Vauxhall Astra J GTC - Noise in the roof lining area | HELLA

Noise in the roof lining area

Figure 1

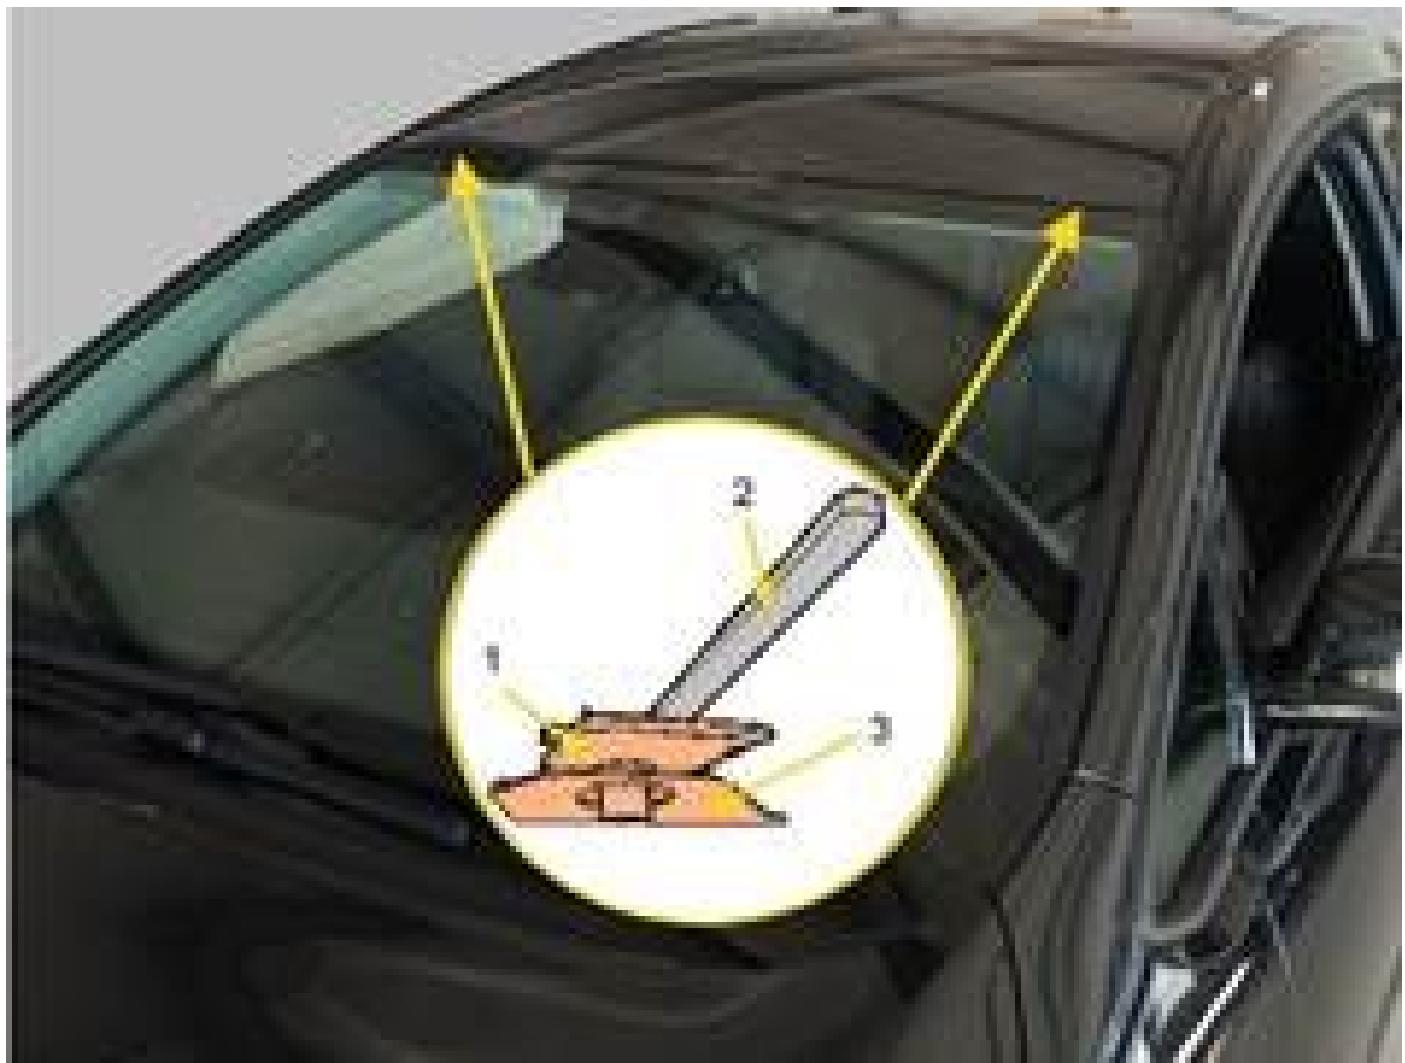
The cause of this noise development could be the clips that were used as a mounting aid for the panorama windshield (figure 1).

The clips may come loose due to heat generation (insolation) for example.

The clips are no longer used in production as of 08/29/2012.
